Technical Memorandum

Re: J160036 – Adverse Water Quality Trends in Meliadine Portal Area

Luis Manzo of the Kivalliq Inuit Association (KIA) requested that Hutchinson Environmental Sciences Ltd. (HESL) review a letter report provided by Agnico Eagle Mines Ltd. (AEM) regarding:

Figure 1. Impacted water bodies at Meliadine Exploration Camp. Blue dotted arrows with black boarder indicate direction of flow. Red dots with a black circle indicate where photographs should be taken.

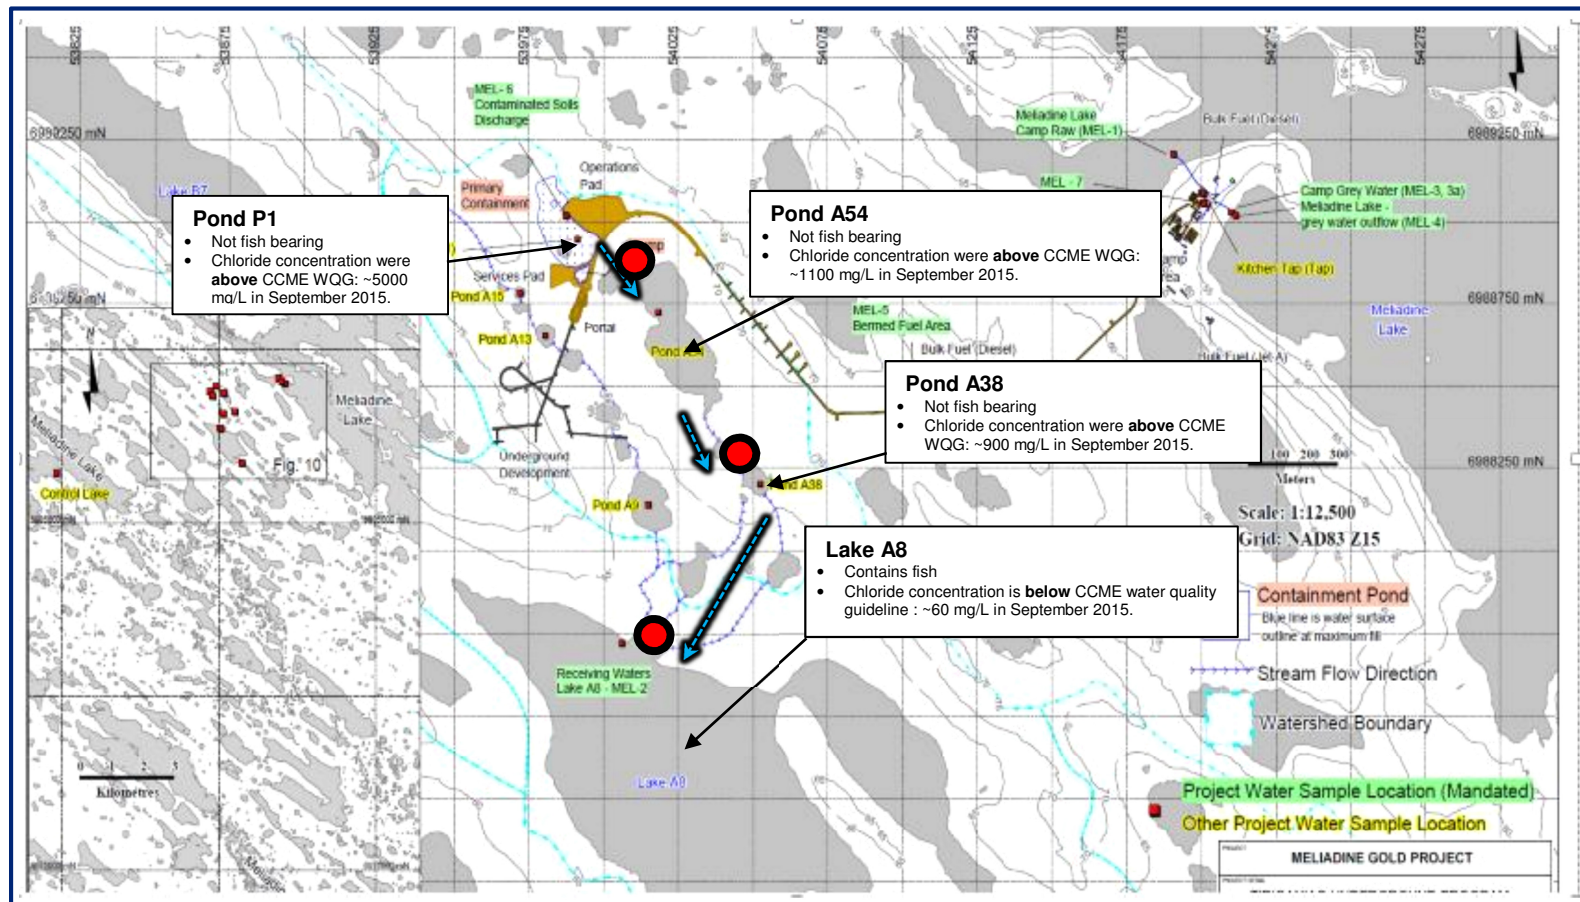
Elevated concentrations were first noted in June, 2015 during freshet. AEM has noted that chloride concentrations in Ponds P1, A54 and A38 are well above the Canadian Council of Ministers of the Environment (CCME) long-term Water Quality Guideline (WQG) for the protection of aquatic life (120 mg/L). Concentrations were measured in September 2015 at approximately 5000 mg/L, 1100 mg/L and 900 mg/L in Ponds P1, A54 and A38, respectively. Nevertheless, these ponds are not considered part of the receiving environment as all freeze solidly to the bottom during winter, are wholly contained within the project footprint and are not fish bearing. All hydraulic connections between these ponds and the final fish bearing receiving water body, Lake A8, are via diffuse flow paths. The direction of flow has been indicated in Figure 1.

The concentrations of ammonia and chloride as presented in AEM's report do not pose an immediate threat to aquatic life. However, we recommend that the KIA conduct monthly inspections of the site during the open water season, photographing the diffuse flow patterns linking Pond P1, A54, A38 and Lake A8. The KIA should ensure that the first inspection occurs during freshet. A photograph looking upstream and downstream should be taken monthly at the locations indicated in Figure 1 throughout the open water season starting at freshet. These photographs are intended to inform the results provided in AEM's report and may assist in a compensation claim should concentrations of chloride and ammonia increase beyond the appropriate CCME WQG.

Figure 2. Measured chloride concentrations in Lake A8.

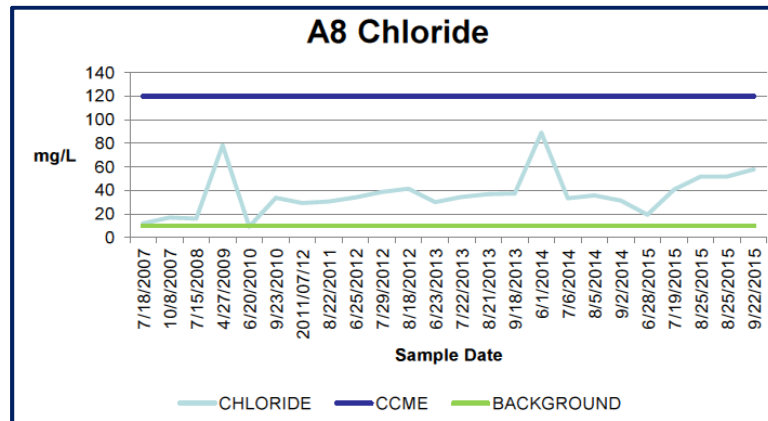
AEM's letter notes that chloride concentrations have increased in Lake A8 since June 2015 but has not exceed the CCME WQG. Measured concentrations are also within the range reported since 2007 (Figure 2).

Figure 3. Conceptual layout plan of P1 Water Management Infrastructure for Freshet 2016 as provided by AEM.

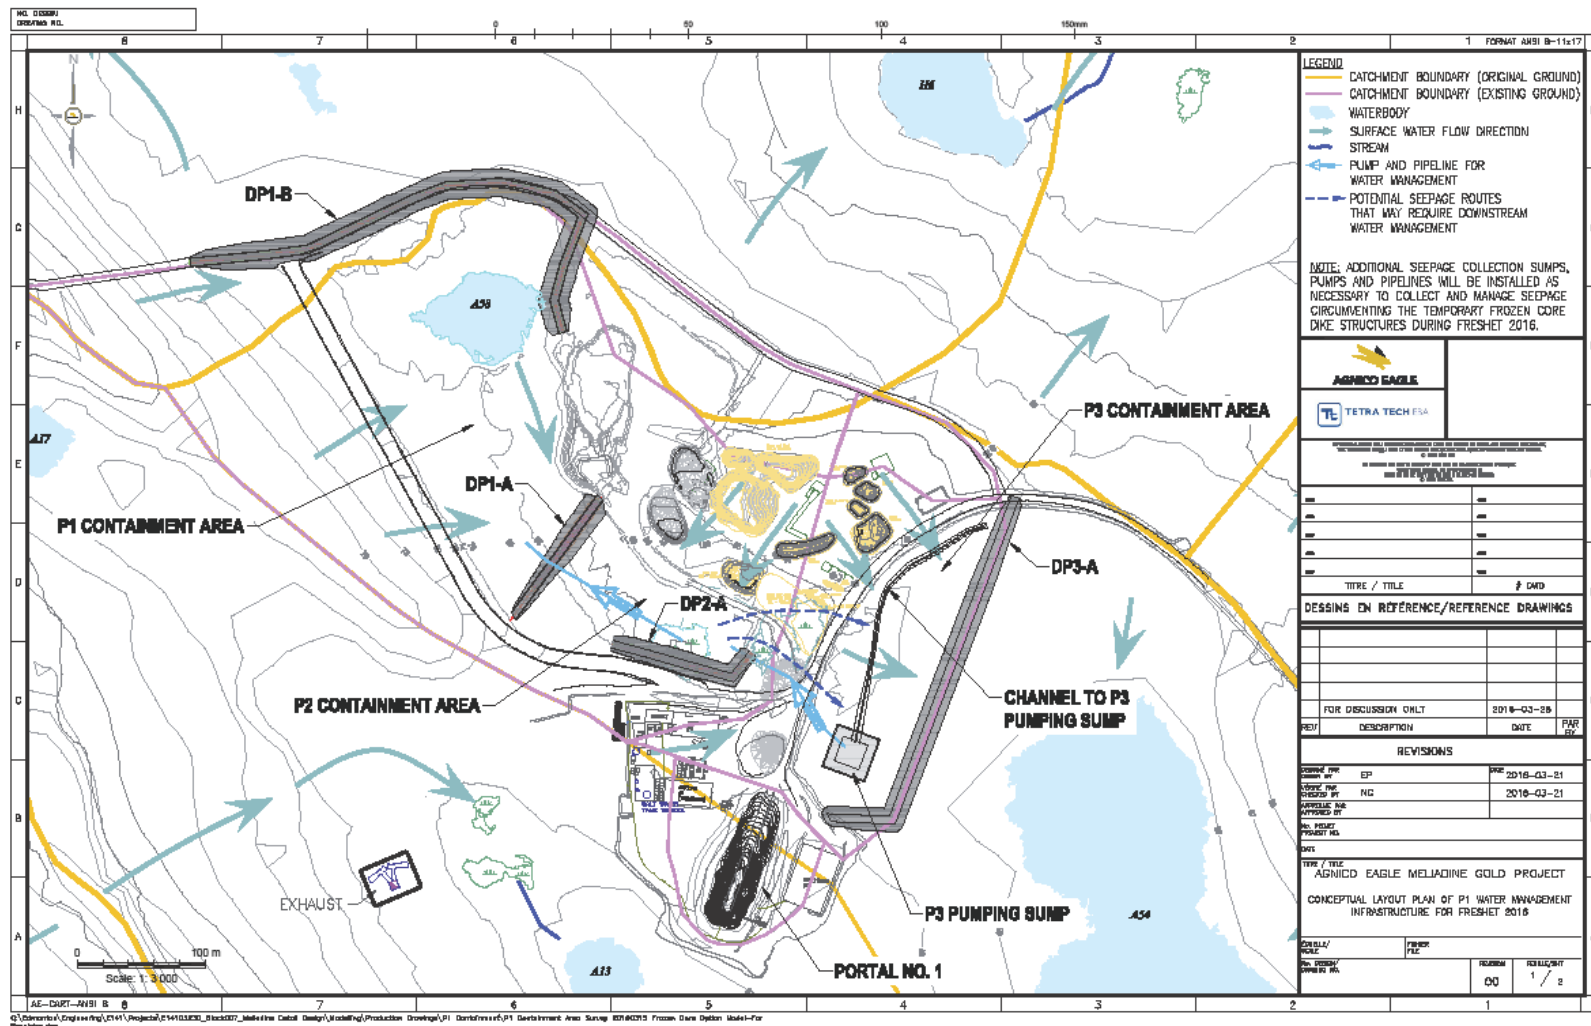
AEM's April 11, 2016 email also indicated that they are working to obtain a "minimal capacity of 32,400m³" for Pond 1. It is unclear how AEM arrived at this value or how much of an increase in capacity this represents. AEM's primary approach for increasing their capacity to store water associated with the portal area is as follows:

AEM has indicated that dykes designed by Tetra Tech will be used to segregate the ponds as per Figure 3. Our concerns regarding AEM's reliance on increasing storage capacity are outlined in our response to action item 3 of Table 1. That is the current source of the chloride and ammonia contaminated water arriving at Pond 1 is not being reduced. However, we note AEM's intention to install and use a pumping station to return seepage water to Pond 1. If used correctly, this will limit that quantity of contaminated water reaching the receiving environment and mitigate impacts to Lake A8. Increasing capacity should only be considered part of the mitigation efforts to address the contaminated water.

- ❖ A discussion of how the required volume of additional storage capacity in Pond P1 was derived. This may be presented as part of a site water balance for exploration activities;
